RTX6001: Mounting Overvoltage Control Circuit

171208

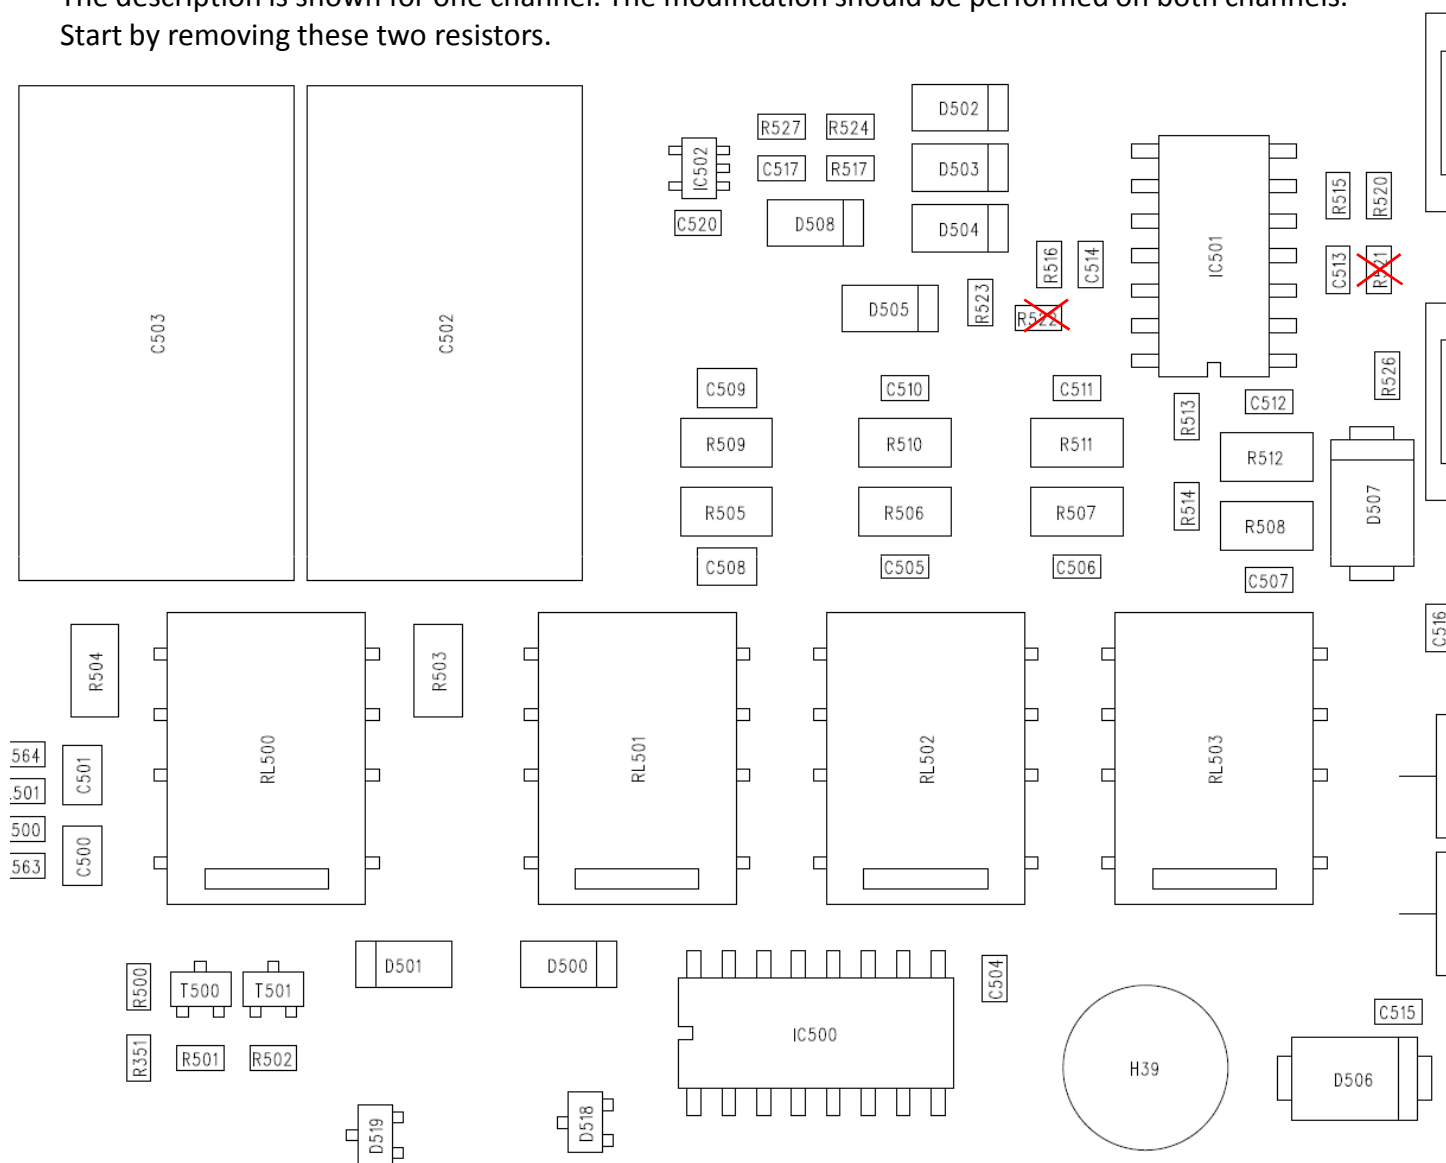
The description is shown for one channel. The modification should be performed on both channels.
Start by removing these two resistors.

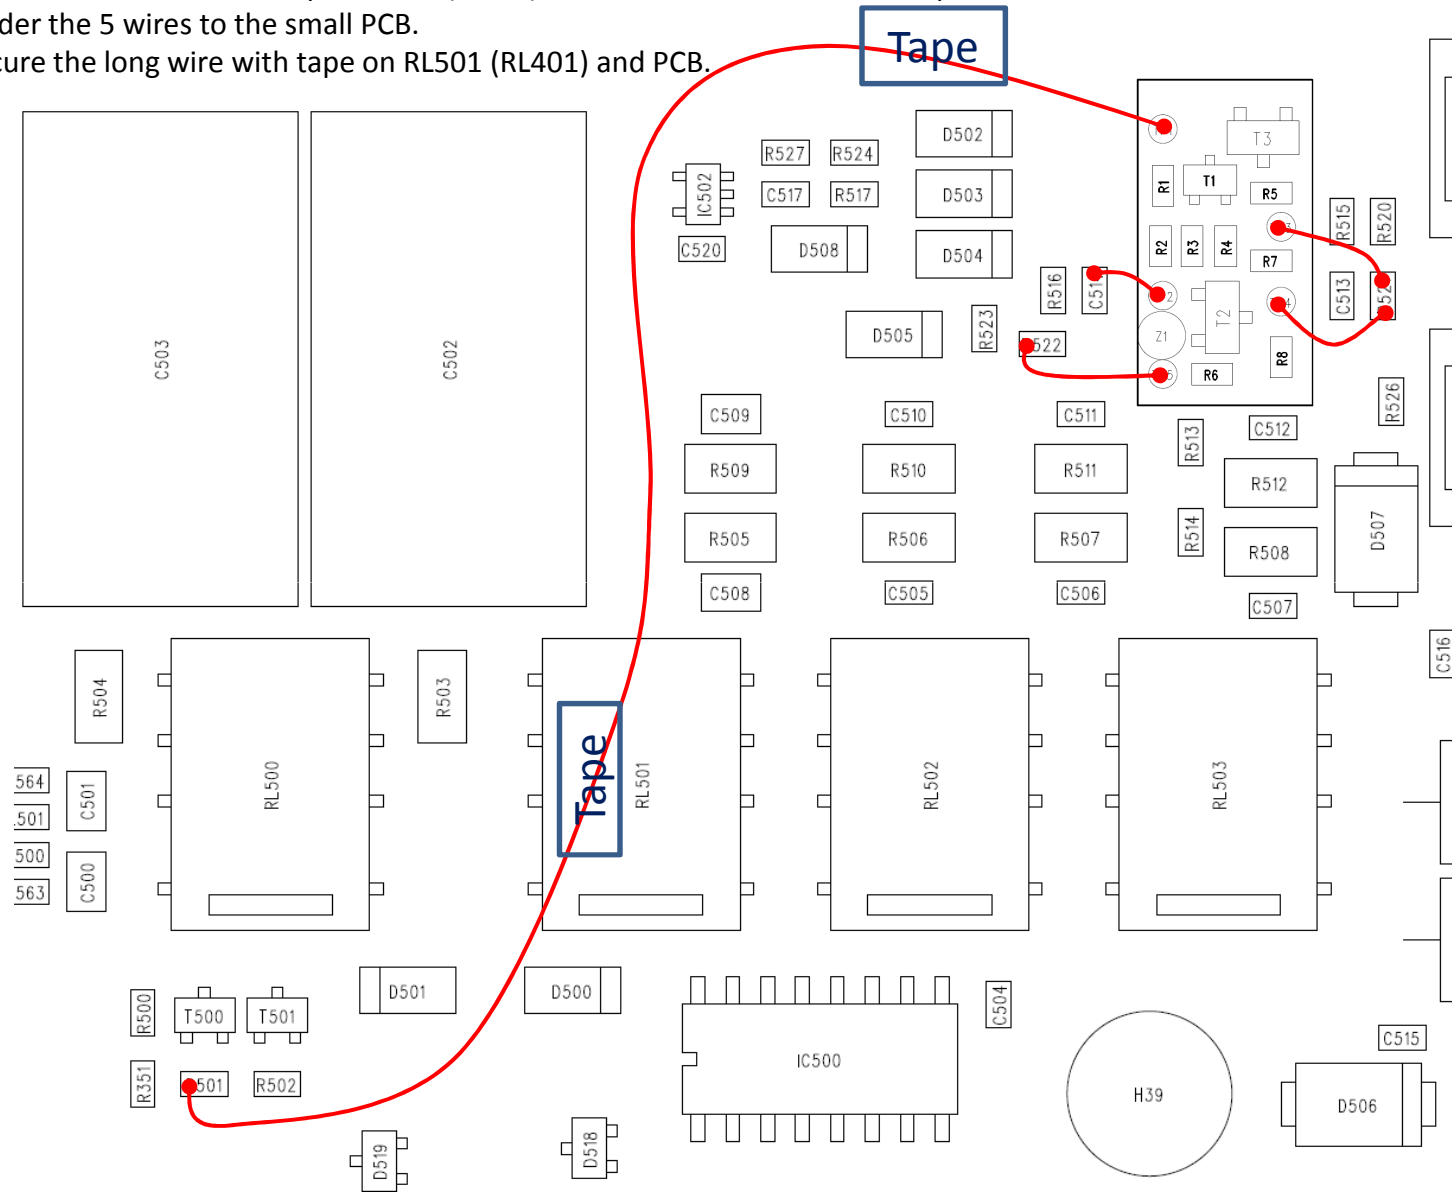
Solder the 4 short wires and one long wire on the Main PCB.

Mount the small PCB on top of IC501 (IC401) with double-sided adhesive tape.

Solder the 5 wires to the small PCB.

Secure the long wire with tape on RL501 (RL401) and PCB.
